Work Field Fashion Wears

Bawpara, Kaultia, Gazipur Sadar , Gazipur

18 March 2015

TABLE B4.1
Limiting Width-Thickness Ratios for
Compression Elements

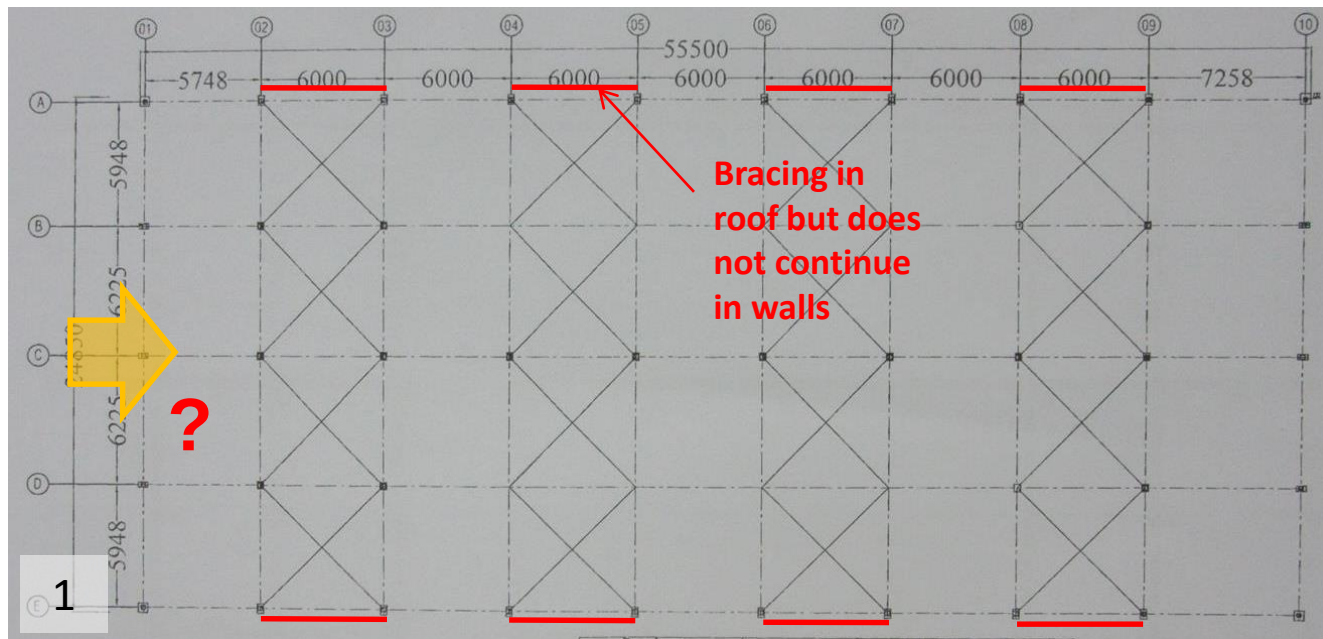
Slender classification sections appear to have been used for some beams and columns

A number of elements are constructed with slender sections and may be susceptible to local section buckling. In addition flange straightness appears to be out of specification.

- 1 Standard AISC section classification limits
- 2 Section sizes
- 3 Column with wavy flange
- 4 Column with wavy flange
